PLANNING AND ZONING CASE CHECKLIST

Project Number: SP2019-016
Project Name: 196/216 Ranch Trail
Project Type: SITE PLAN
Applicant Name: DUB DOUPHRATE
Owner Name: JERRY, KISICK CUSTOM HOMES INC
Project Description:

**SITE PLAN A
LOT 5, BLOCK 4
REPLAT OF MAVERICK RANCH ADDITION
CITY ROCKWALL
ROCKWALL COUNTY, TEXAS**

TO: Planning and Zoning Commission
DATE: 06/11/2019
APPLICANT: Dub Douphrate; *Douphrate and Associates, Inc.*
CASE NUMBER: SP2019-016; *Site Plan for Office Buildings on Ranch Trail*

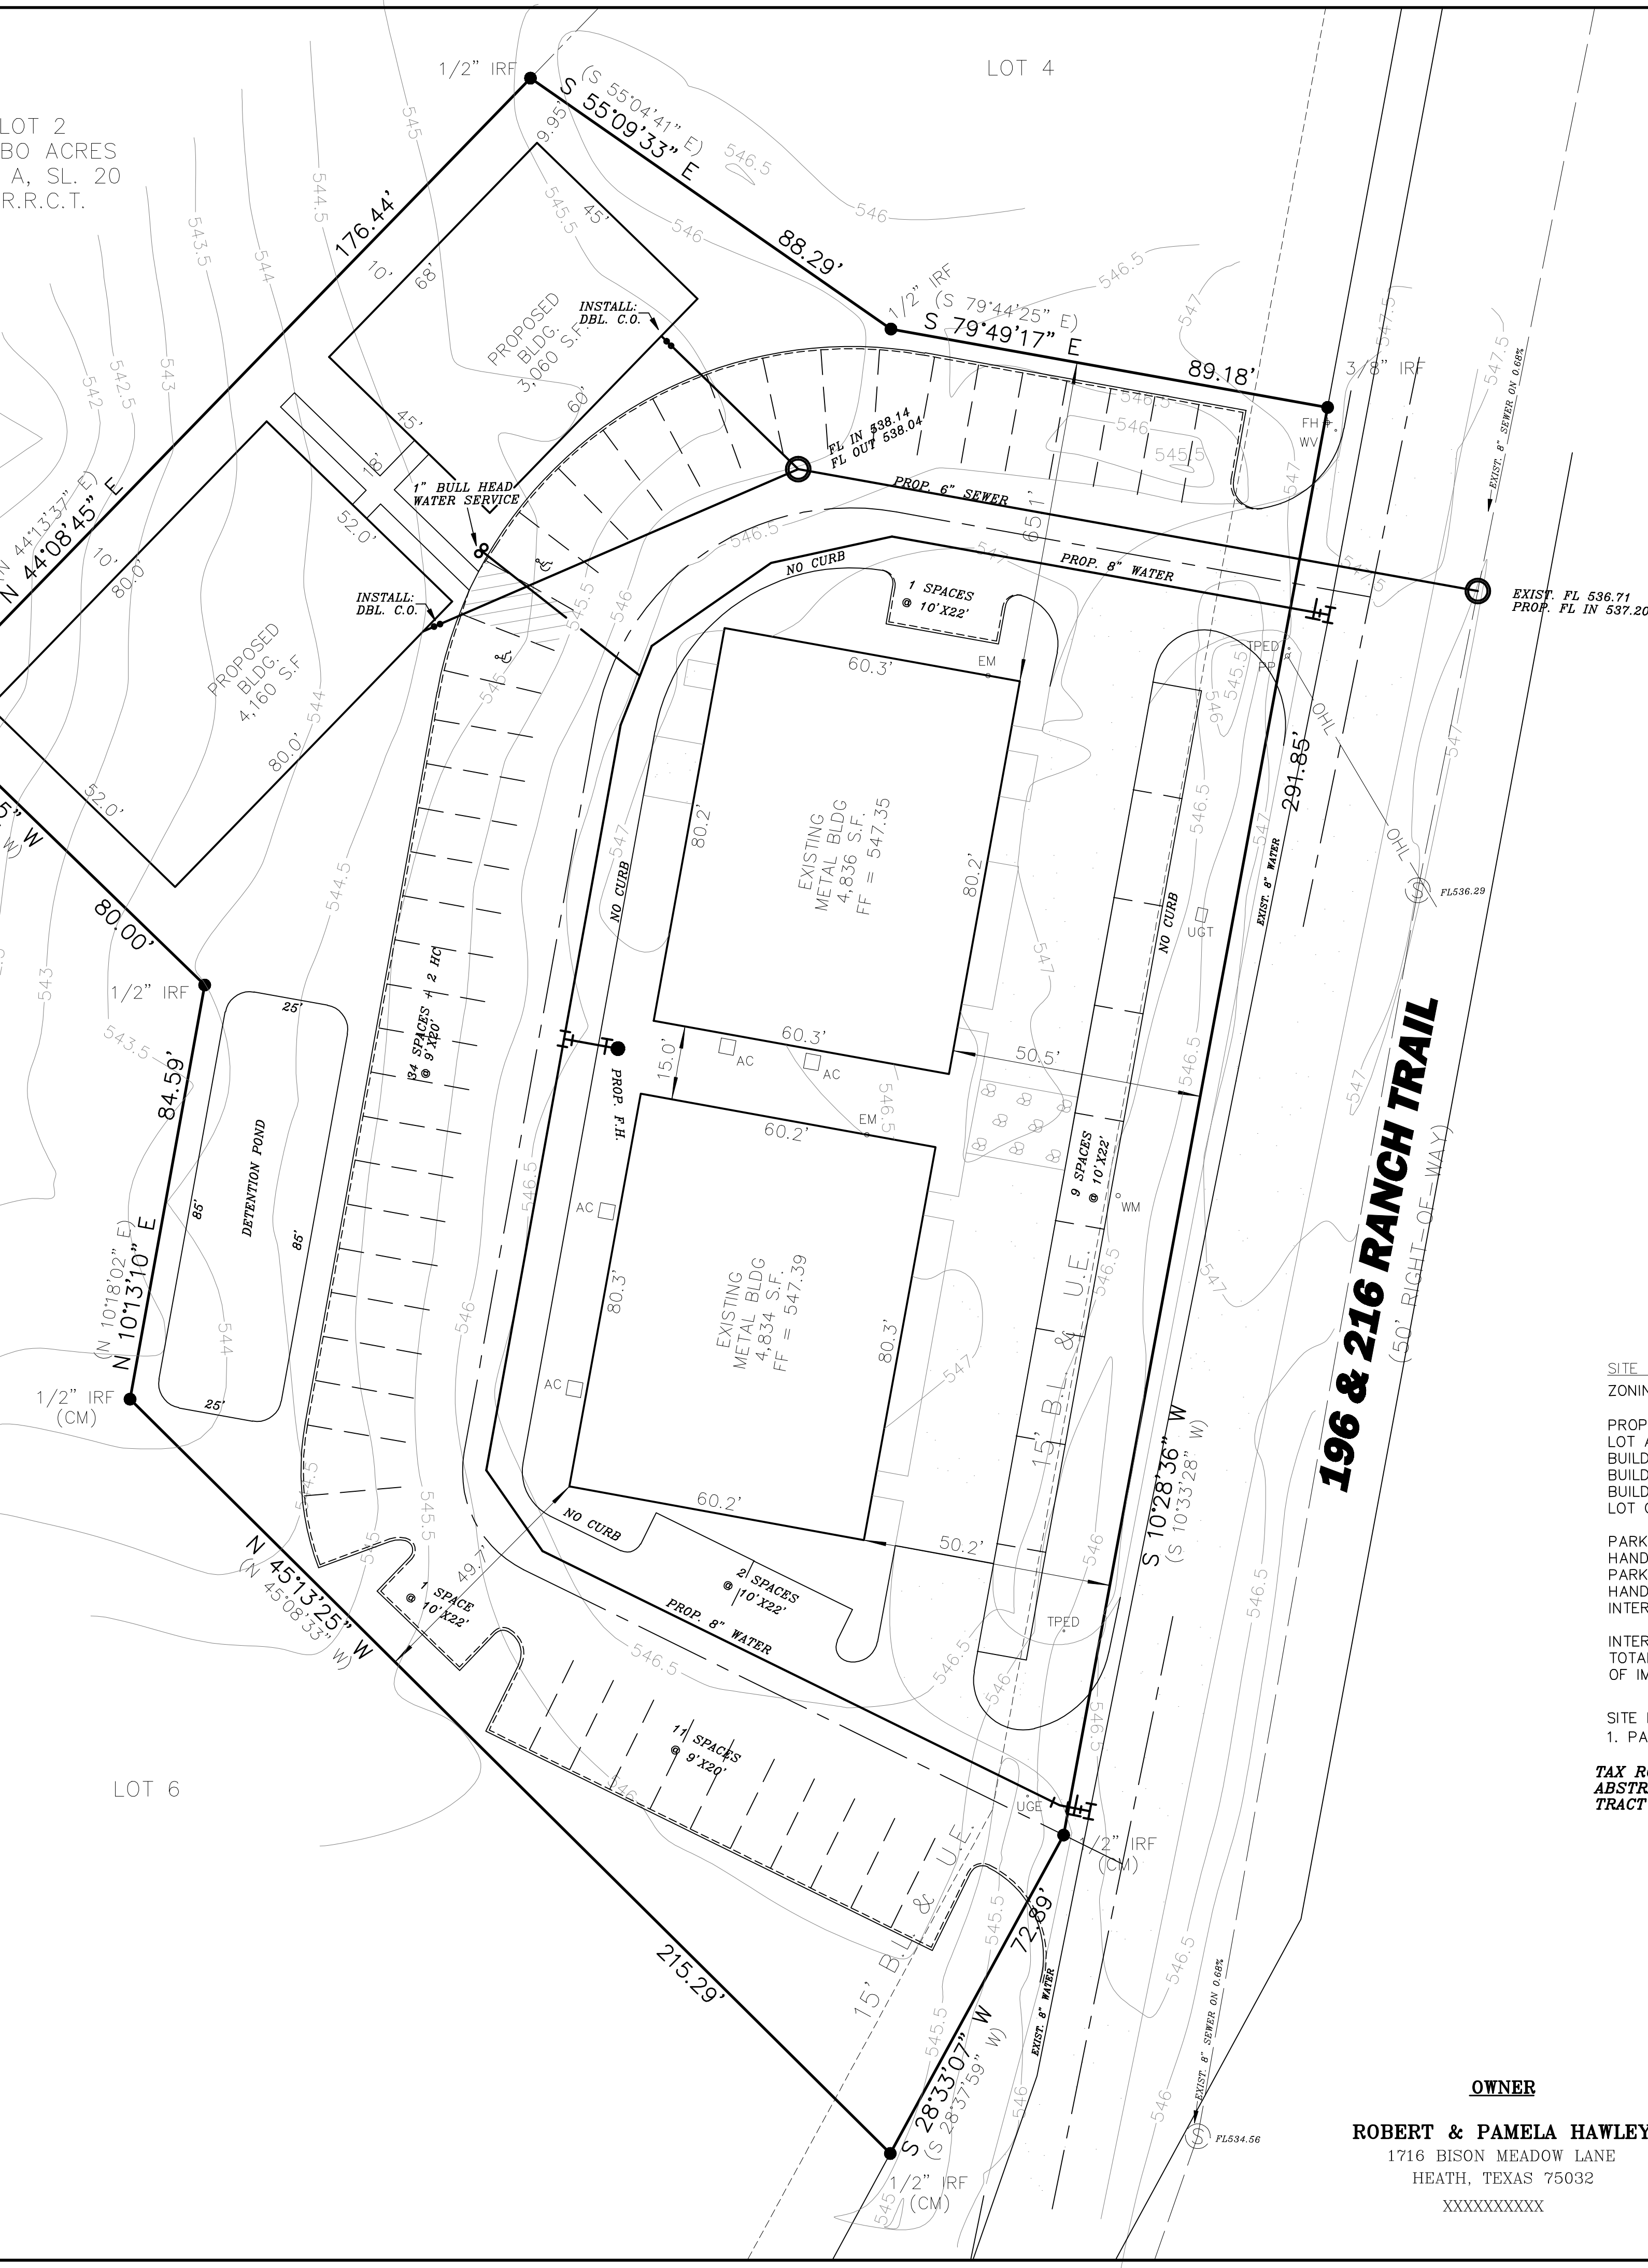
Type of Review / Notes	Contact	Sent	Due	Received	Elapsed	Status	Remarks
FIRE (5/23/2019 1:38 PM AA) Show location of proposed fire lane on the site plan. An approved water supply capable of supplying the required fire flow for fire protection shall be provided. A water flow test verifying capabilities shall be witnessed by the Fire Marshal Division prior to vertical construction.	Ariana Hargrove	5/17/2019	5/24/2019	5/23/2019	6	COMMENTS	see comments
GIS (5/22/2019 9:58 AM LS) New addresses will be: 4160 sf - 200 RANCH TRAIL, ROCKWALL, TX 75032 3060 sf - 224 RANCH TRAIL, ROCKWALL, TX 75032	Lance Singleton	5/17/2019	5/24/2019	5/22/2019	5	APPROVED	See comments
PLANNING	David Gonzales	5/17/2019	5/24/2019	5/23/2019	6	COMMENTS	See comments

1. Provide adjacent property owner information on Overall Site Plan(aerial version).
2. Label all access easements as "24-ft Firelane, Public Access, Drainage and Utility Easements (as appropriate for each).
3. Provide a heavier line for the utility label and reduce the font. Move labels to be more visible.
4. Use lighter gray scale for the utility lines layer(water & sewer).
5. All ground mounted HVAC units must be screened with landscaping or wing-wall.
6. What are the proposed uses for these buildings? (i.e. this is a commercial district).
7. Delineate and label a minimum 10-ft. landscape buffer along Ranch Trail
8. Remove the label "Replat of" from the Title Block on all pages of this site plan.

216 RANCH TRAIL
FRONT - LEFT ELEVATION

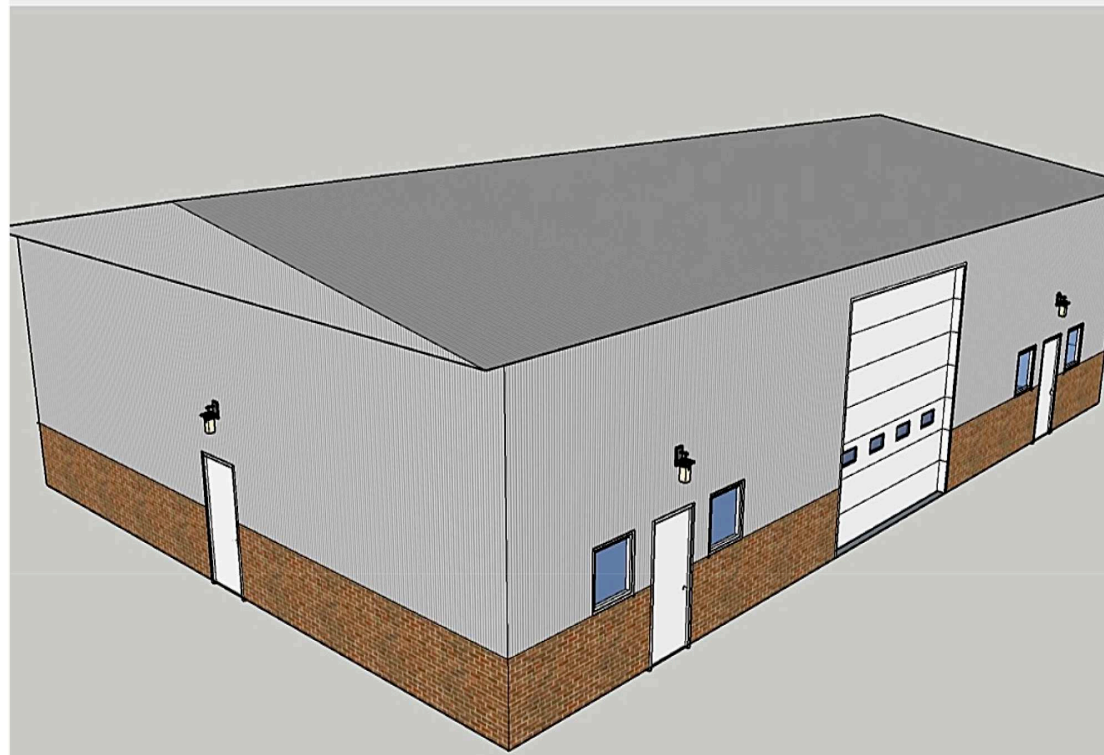
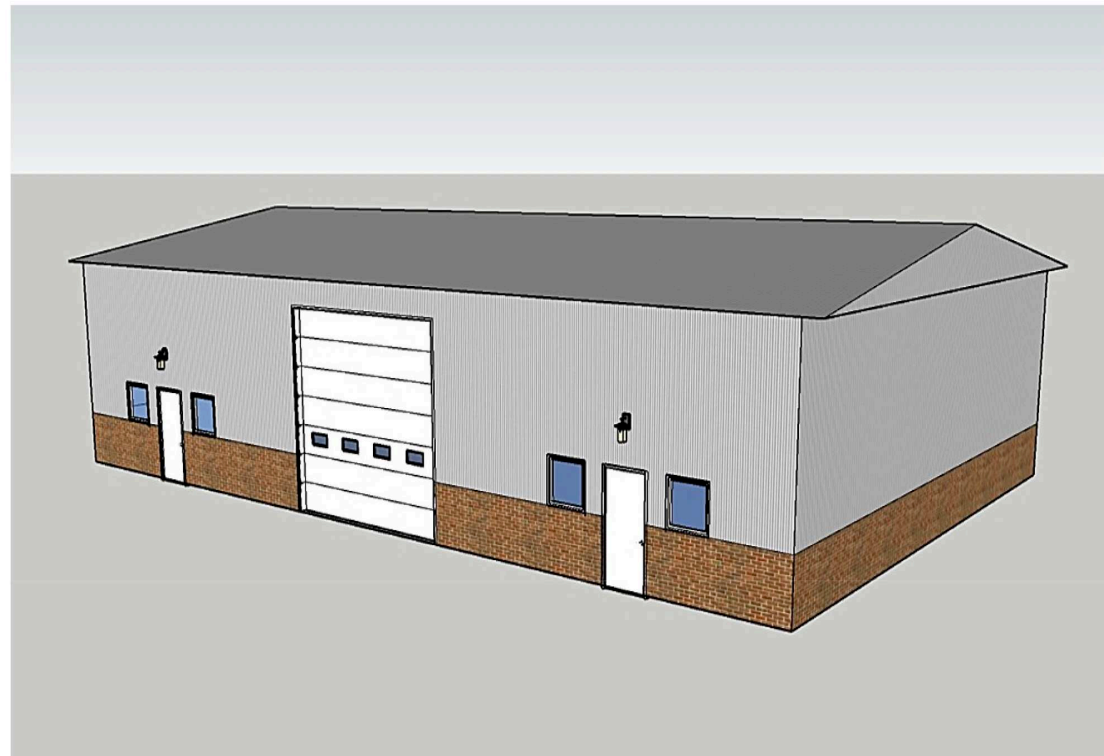
1. Horizontal articulation standards of the UDC for facades
2. Minimum 20% stone requirement for all facades that are visible from a public street or open space
3. For the use of metal building construction (materials exception).

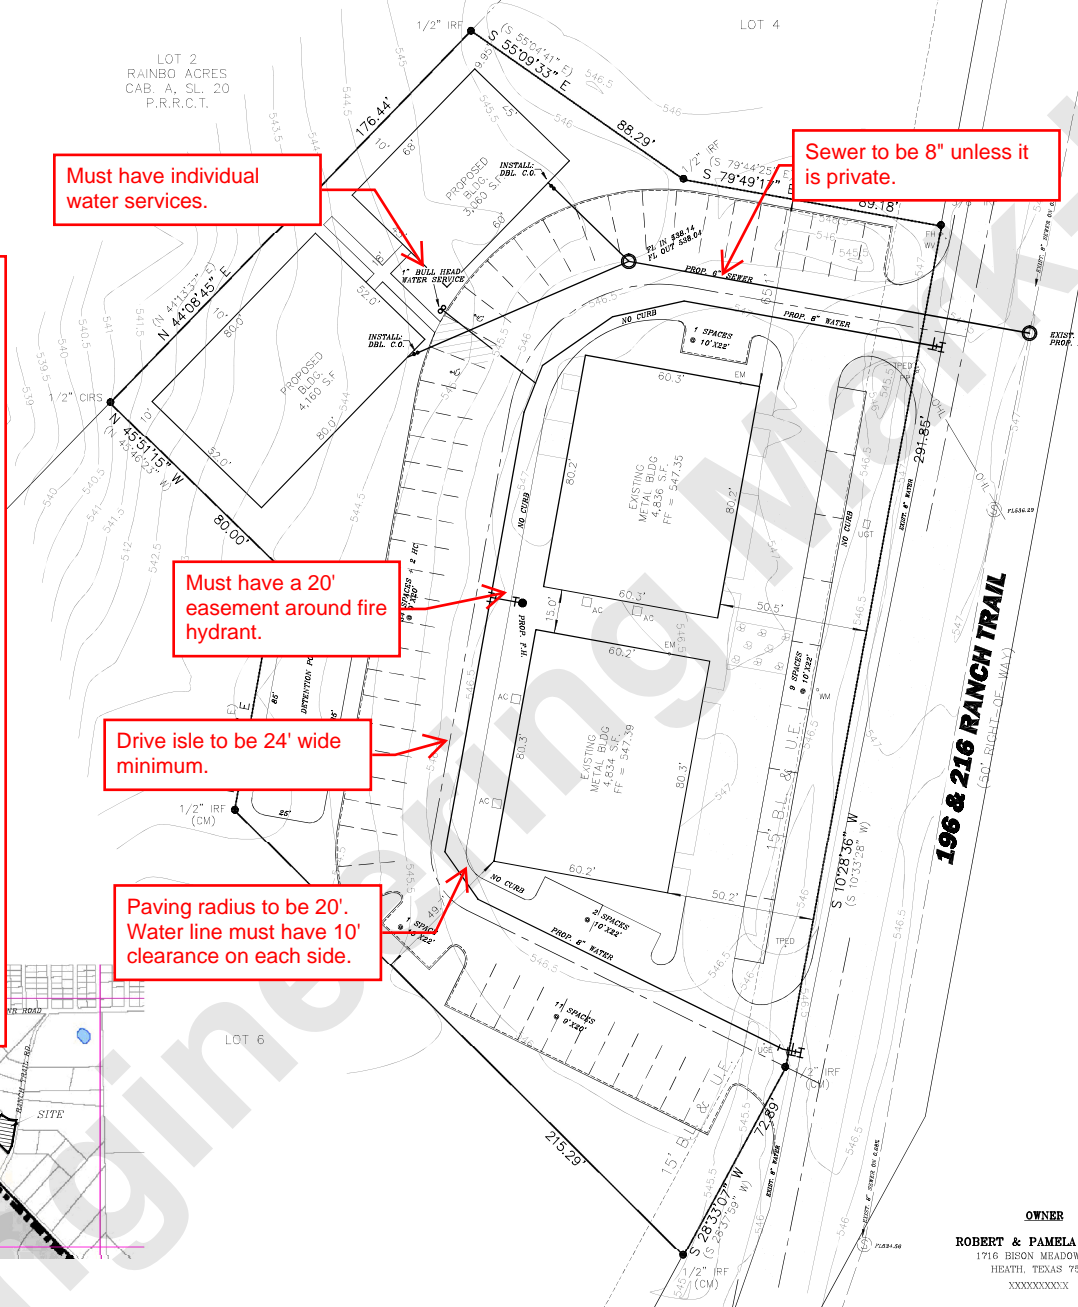
Must have individual water services.

Sewer to be 8" unless it is private.

Must have a 20' easement around fire hydrant.

Drive isle to be 24' wide minimum.

Paving radius to be 20'. Water line must have 10' clearance on each side.

216 RANCH TRAIL
FRONT - LEFT ELEVATION

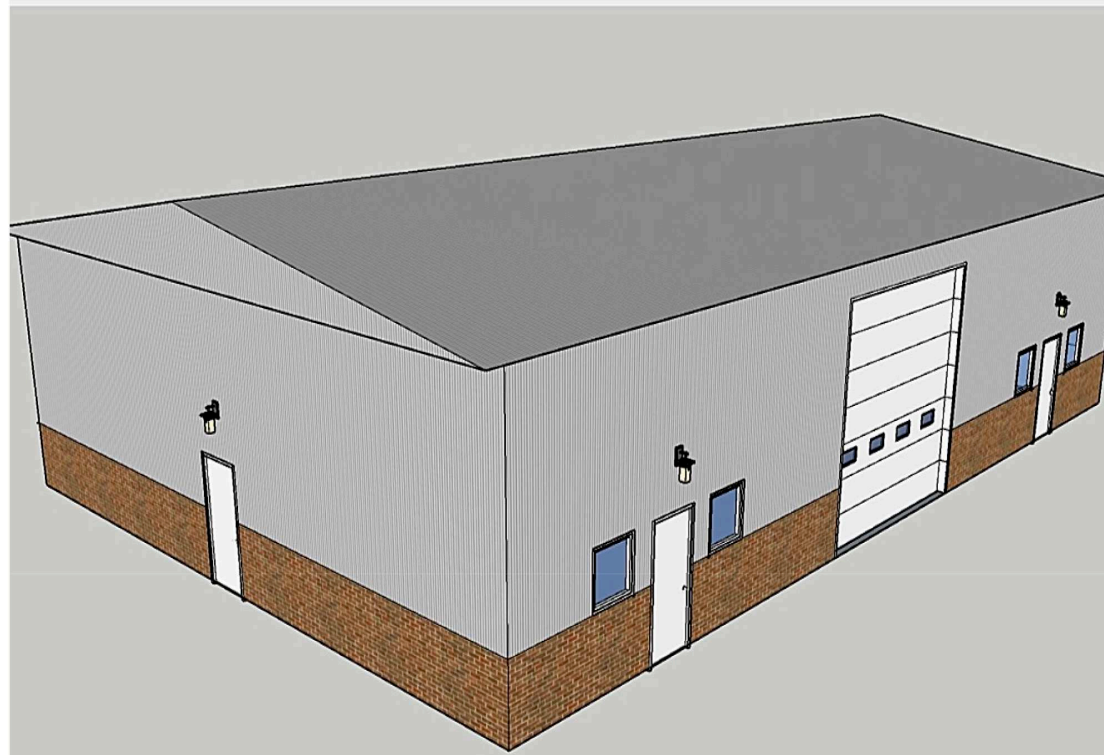
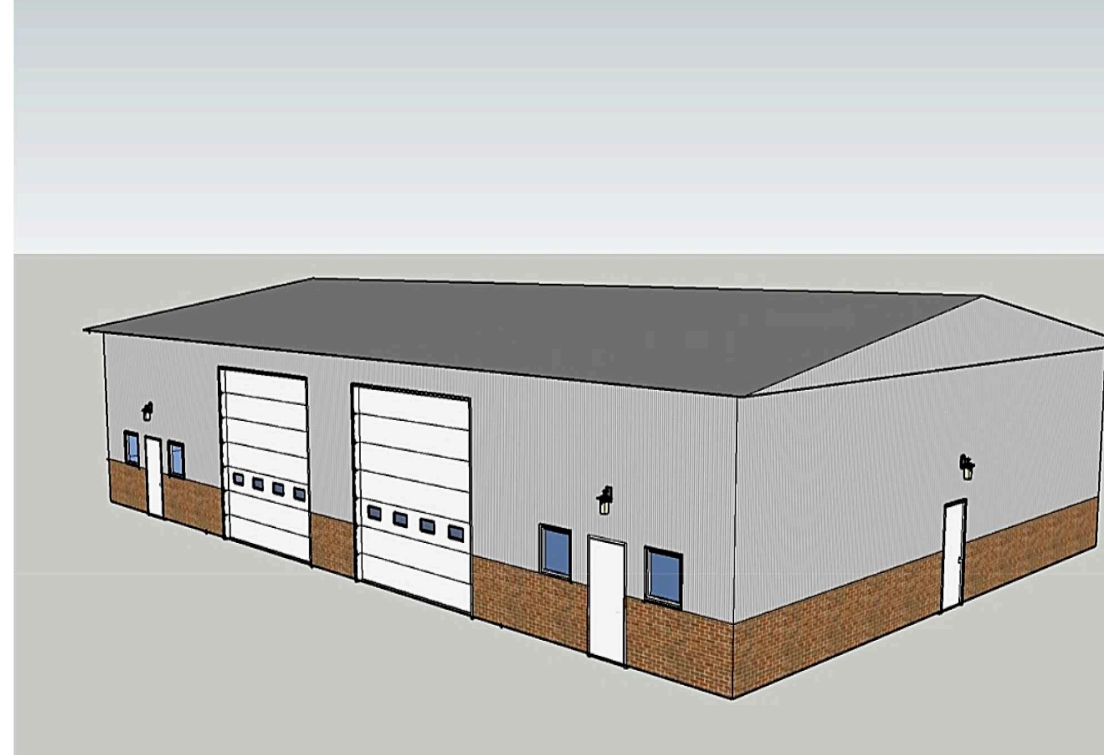
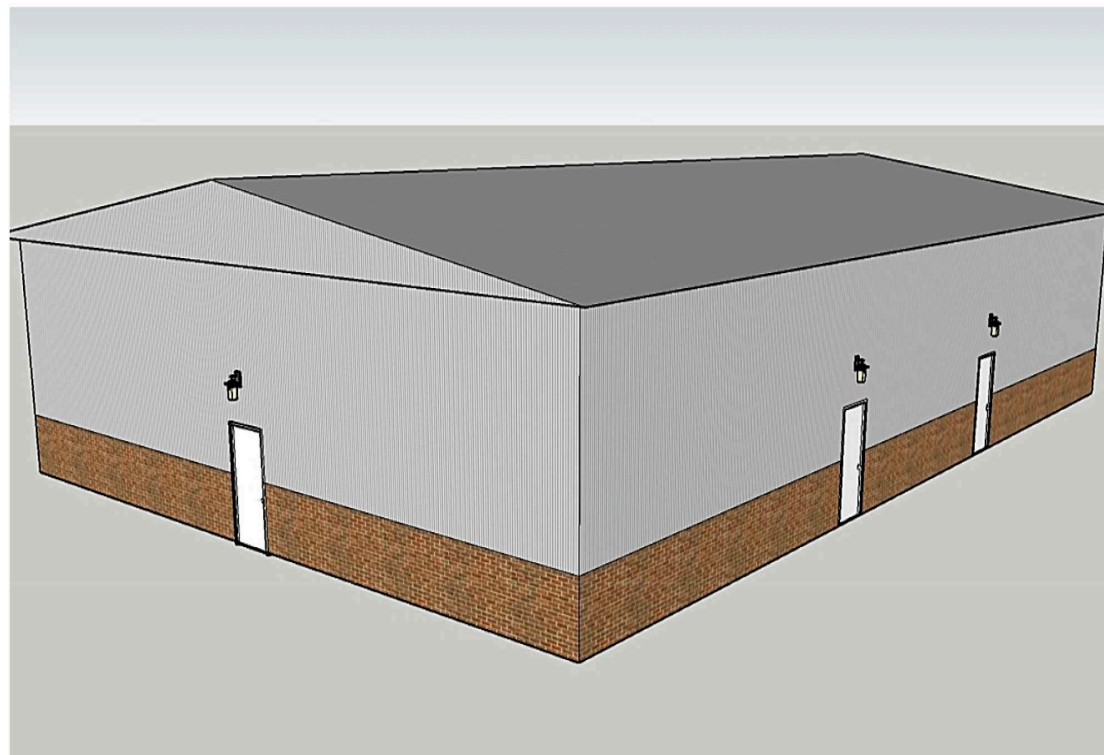
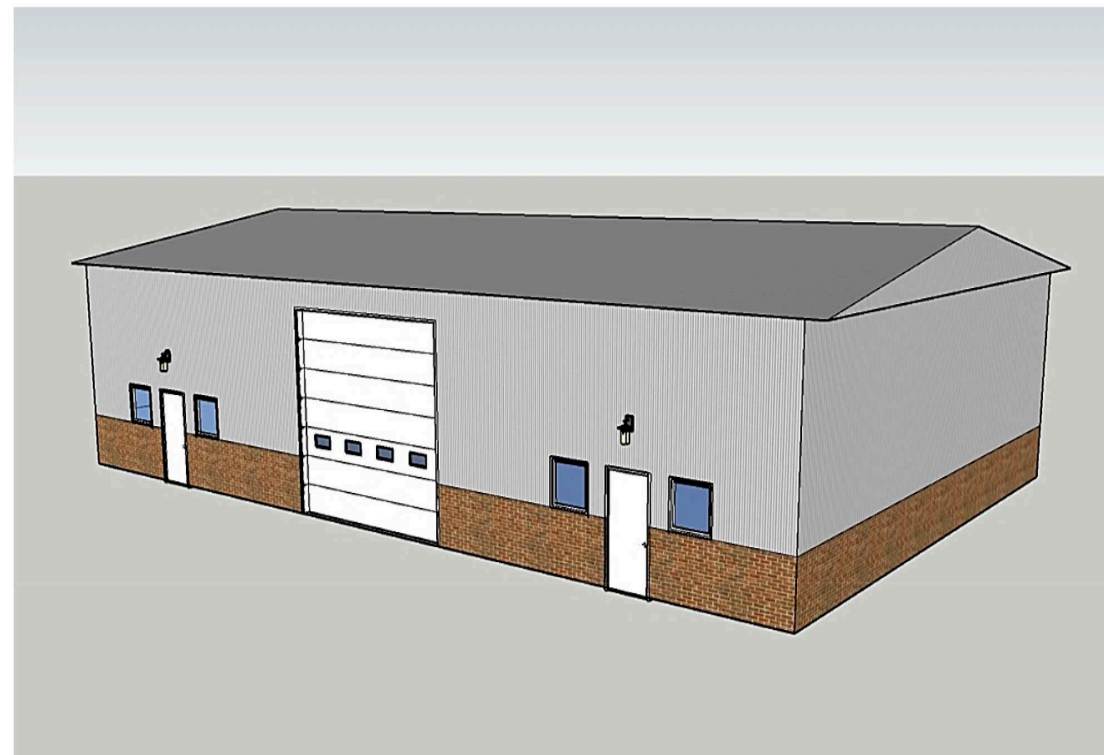
- 1. All gounded mounted mechanical equipment requires screening from rights-of-way and adjacent properties. Provide detail of screening to be used
- 2. Requires a recommendation from the Architectural Review Board(ARB). See scheduled meeting below.
- 3. Provide a materials sample board for ARB review of the actual materials to be used(other than tilt-up wall).
- 4. Provide percentages of exterior material calculations for each elevation(e.g. stone, brick, metal surface, etc.).
- 5. Will there be any stone on the building? The UDC requires a minium of 20% stone on each elevation that is visible from a public street or open space. If there is no stone, this will require approval of an exception by the Planning and Zoning Commission
- 6. Are the elevations for the proposed buildings or all?
- 7. Provide height and width measurements of the proposed buildings.

1. Screening of ground mounted HVAC units required(see note on plans).						
Building Elevations:						
1. Requires a recommendation from the Architectural Review Board(ARB). See scheduled meeting below.

2. Provide percentages of exterior material calculations for each elevation(e.g. stone, brick, metal surface, etc.).						
3. The UDC requires a minimum of 20% stone on each elevation that is visible from a public street or open space. If there is no stone, this will require approval of an exception by the Planning and Zoning Commission.

4. Provide height and width measurements of the proposed buildings.						
** The following are scheduled meeting dates that you and/or your representative(s) are required to attend regarding the Site Plan request. If you have any questions regarding this case, please feel free to contact David Gonzales, AICP with the Planning Department at 972-771-7745.						
Meeting Dates to Attend						
Architectural Review Board: June 11, 2019 (5:00 p.m.) [Subsequent meeting if necessary]						
Planning - Action: June 11, 2019 (6:00p.m.) [P&Z to take action (i.e. approve, approve with conditions, deny)]
